Date: January 30, 2020
To: Cumberland Planning Board
From: Carla Nixon, Town Planner
Subject: **Christmas Creek Subdivision Revision**

Date January 30, 2020
To Town of Cumberland Planning Board
From Carla Nixon, Town Planner
Subject **Amendment to 20 Lot Major Subdivision –Christmas Creek**

18-015 - BZP Cumberland Subdivision

SUBDIVISION PLAN

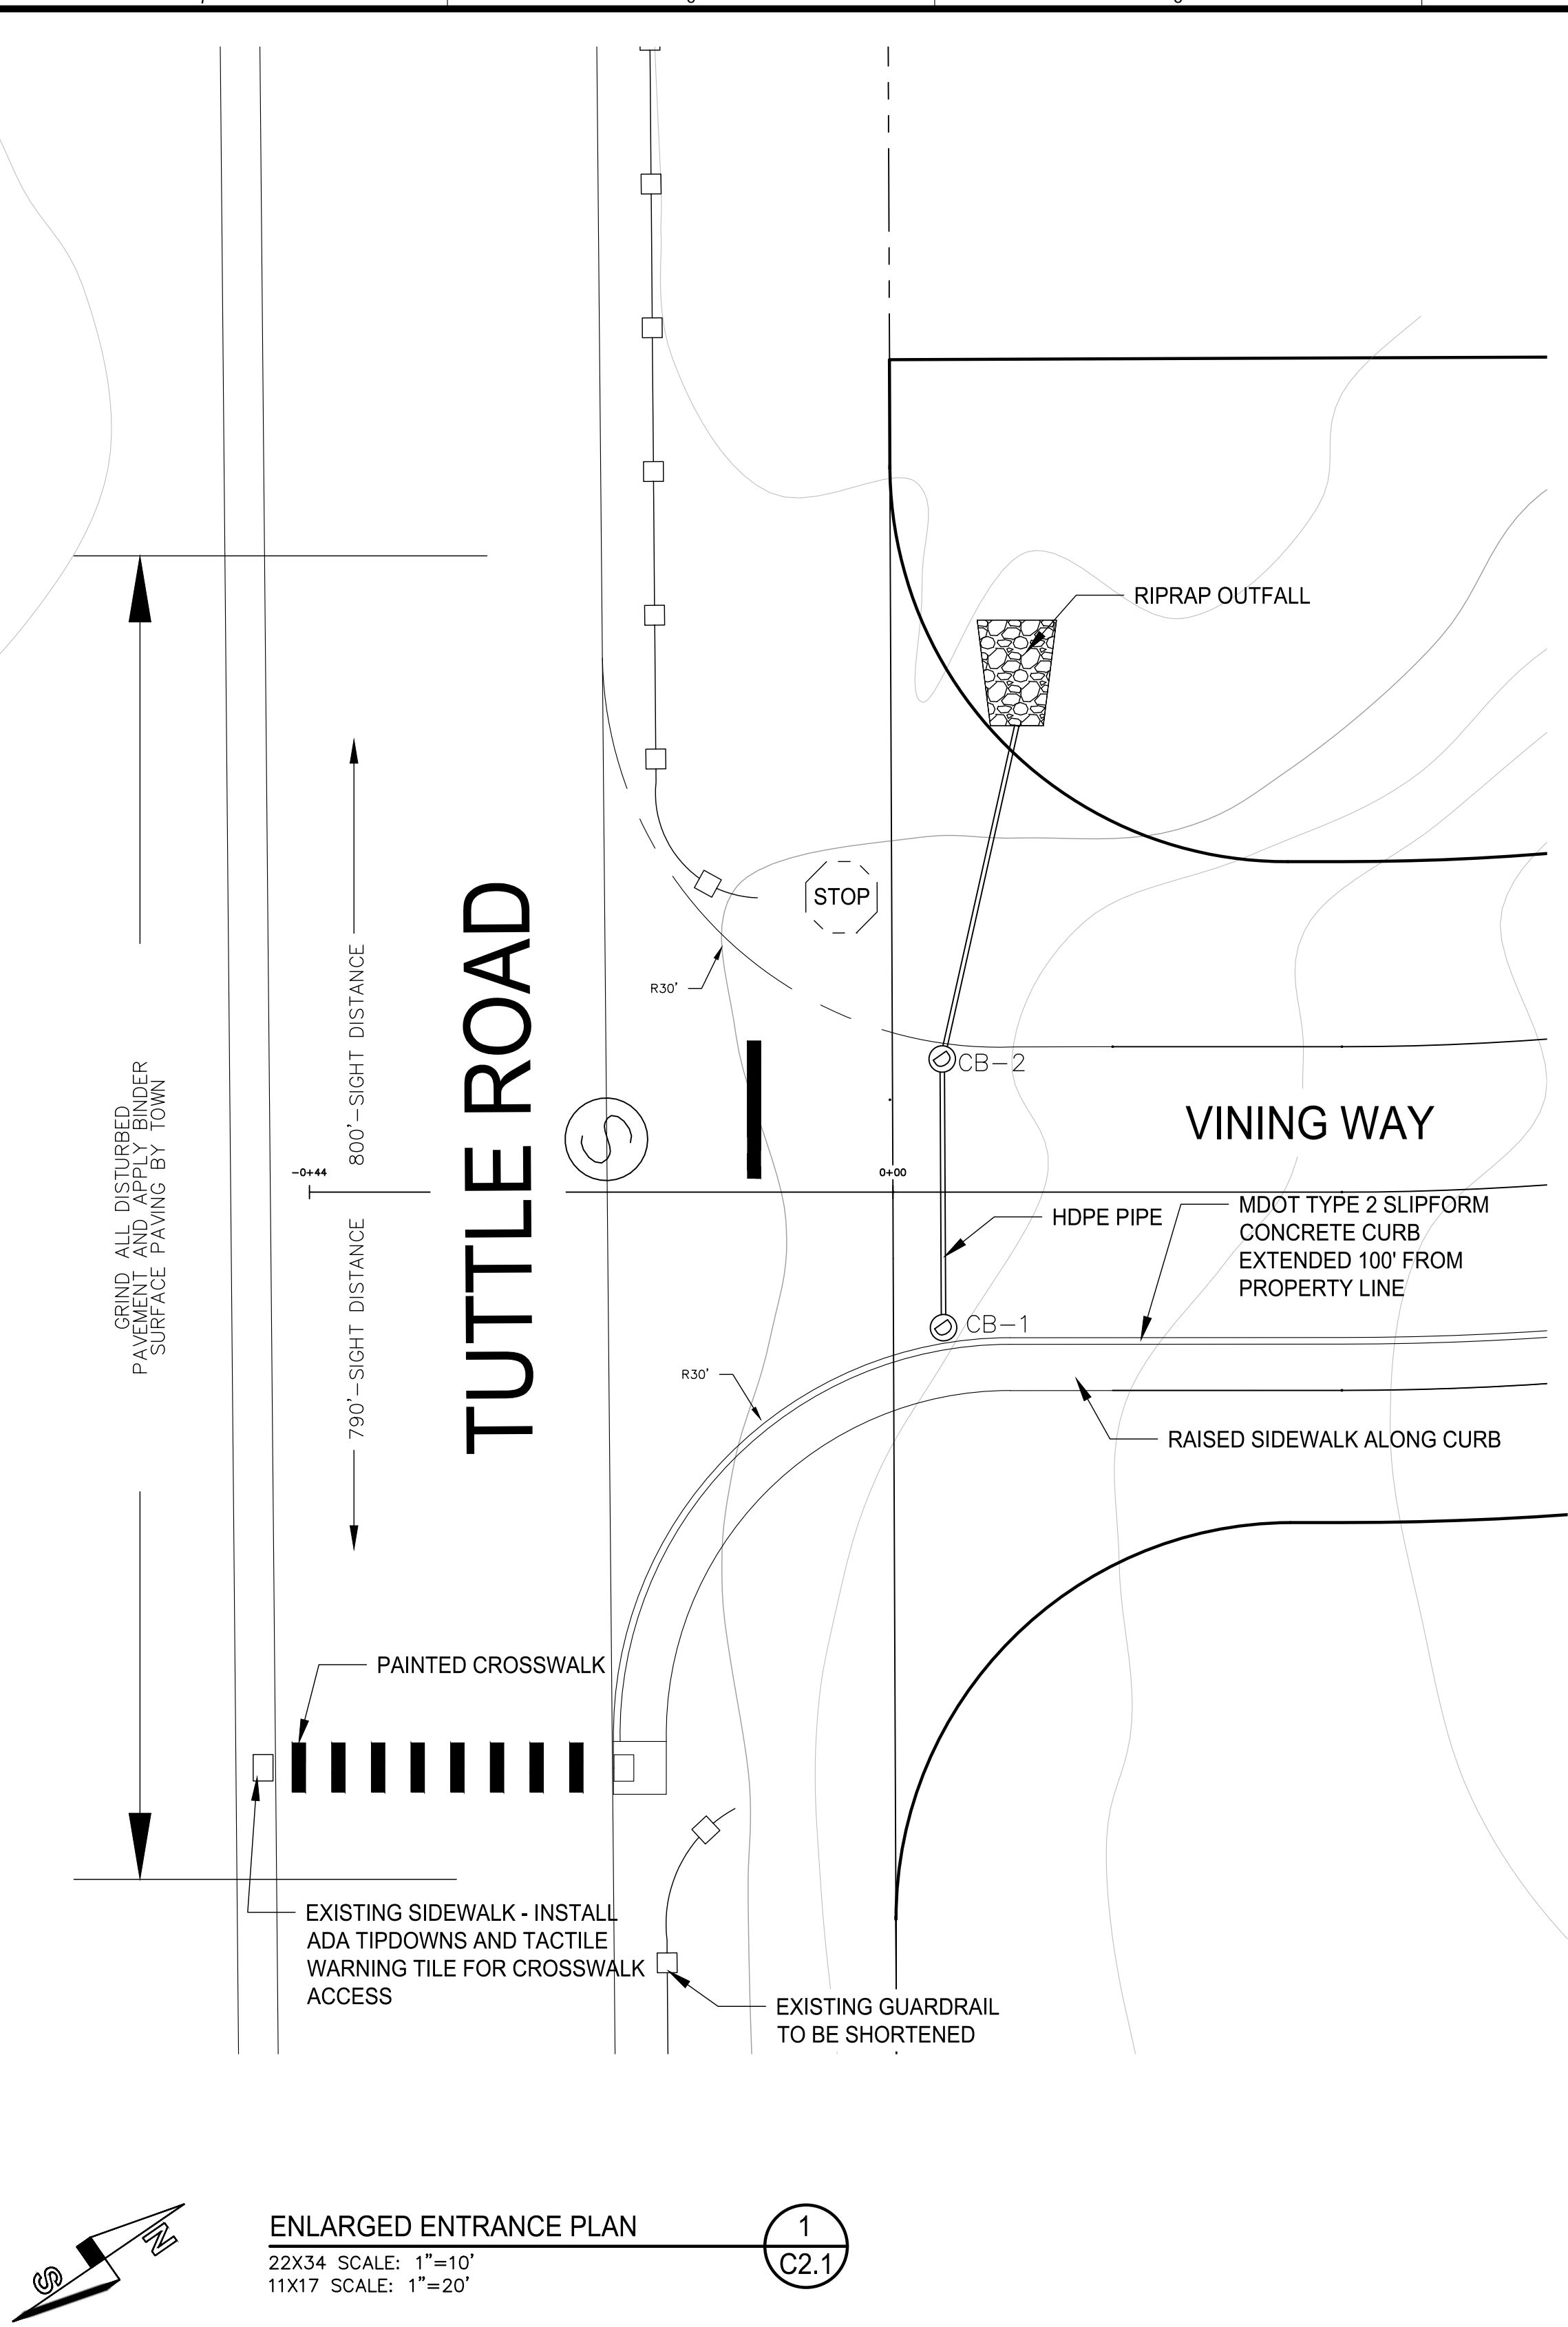
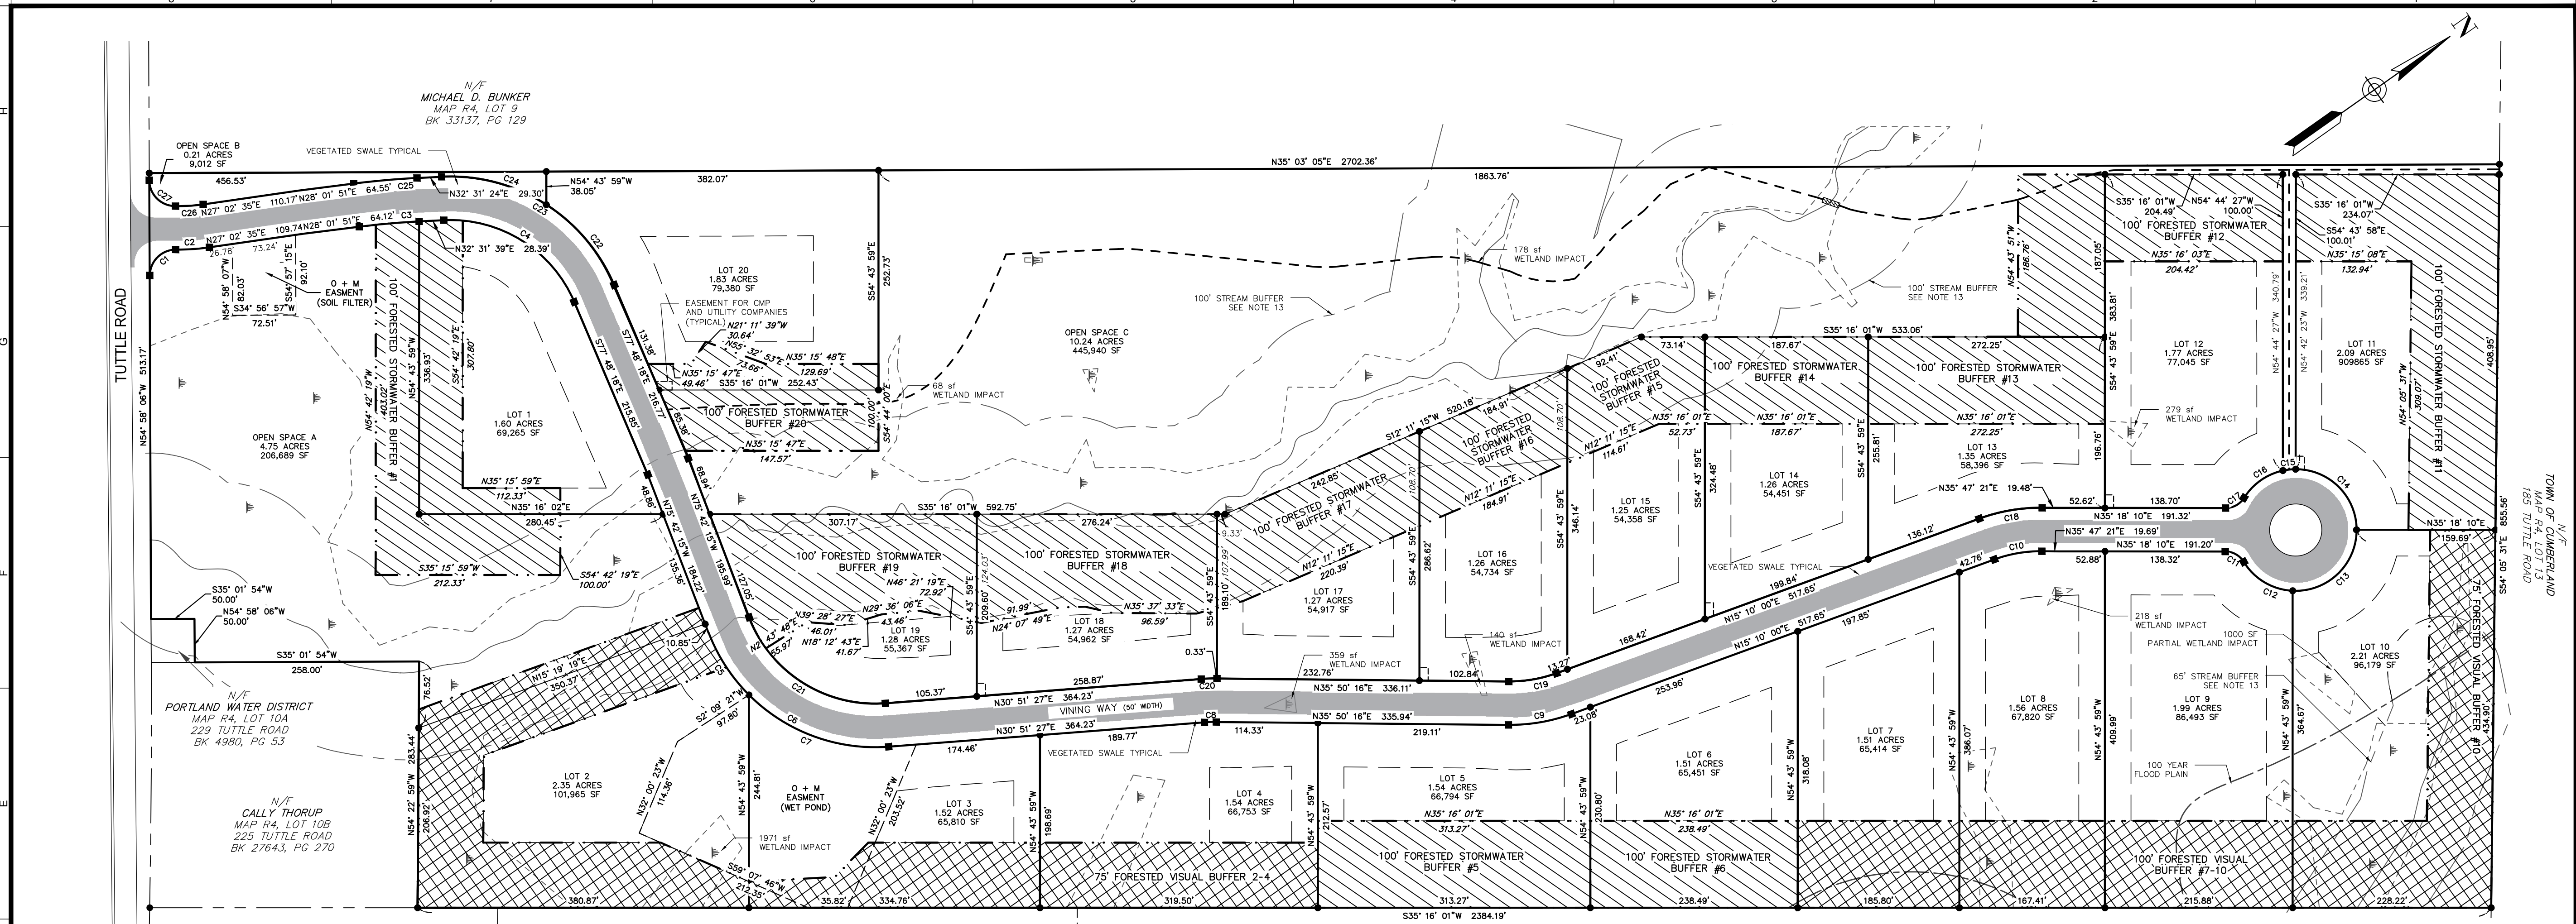
This is a subdivision amendment for the realignment of the subdivision entrance. The change is needed in order to avoid the need to relocate an existing utility pole and guardrail on Tuttle Road.

The purpose of the change to the Subdivision Sheet is to better align the proposed roadway with the existing farmers road on the property. The changes are limited from the road entrance to station 3+00. All buildable property lines have stayed the same as the previous submission. Open Space A & B have changed slightly in there areas but overall its the same acres being dedicated to Open Space for the project.

1. Revised Subdivision Plan. Sheet C2.0
2. Updated Grading and Utility Sheets

ENLARGED ENTRANCE PLAN

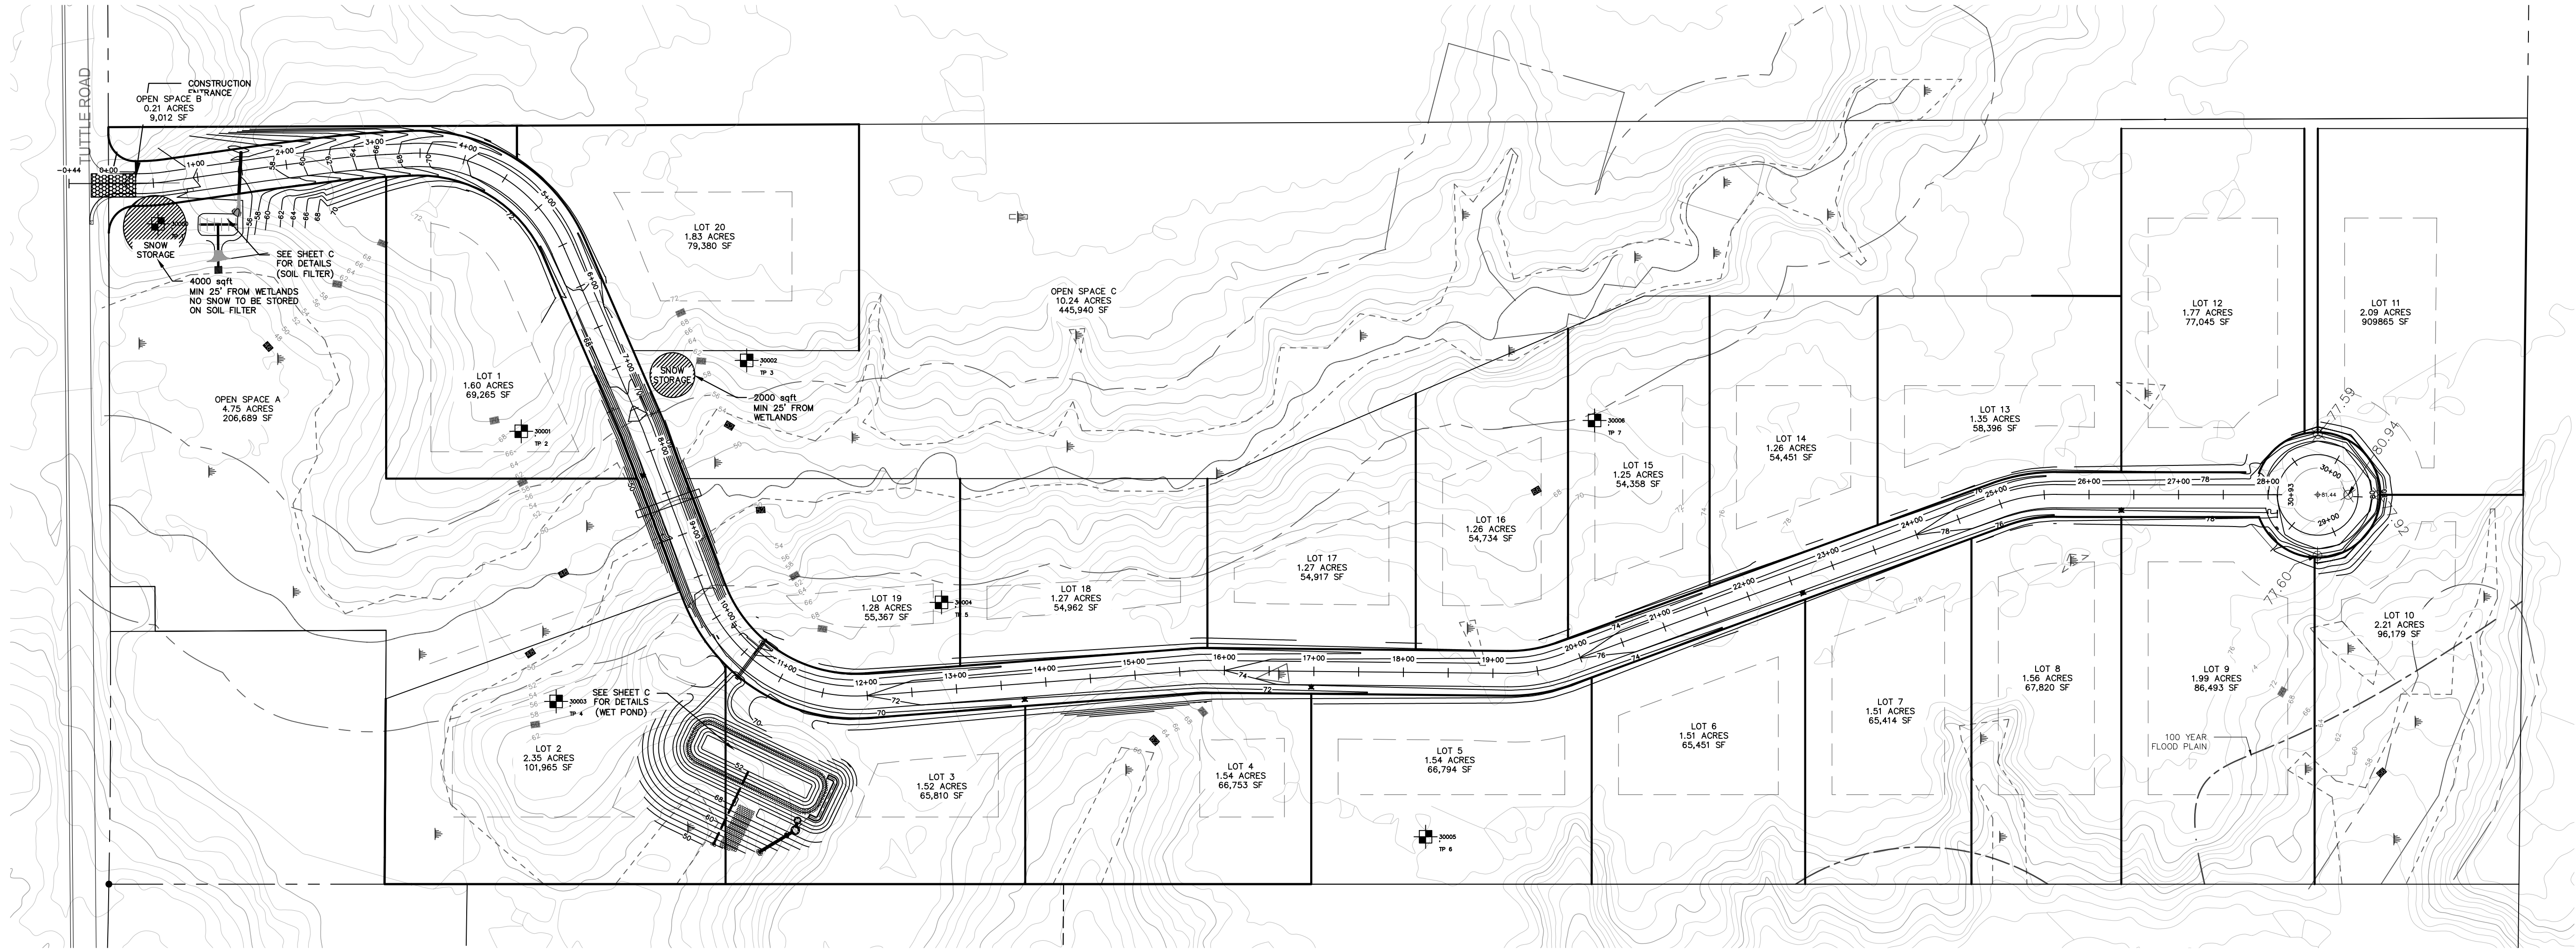
REV.	DATE	DESCRIPTION
7	9/25/19	REVISED PER DEP COMMENTS
8	12/23/19	REVISED ENTRANCE PLAN - ISSUED FOR TOWN APPROVAL
9	01/07/20	REVISED UTILITY PLANS - PWD
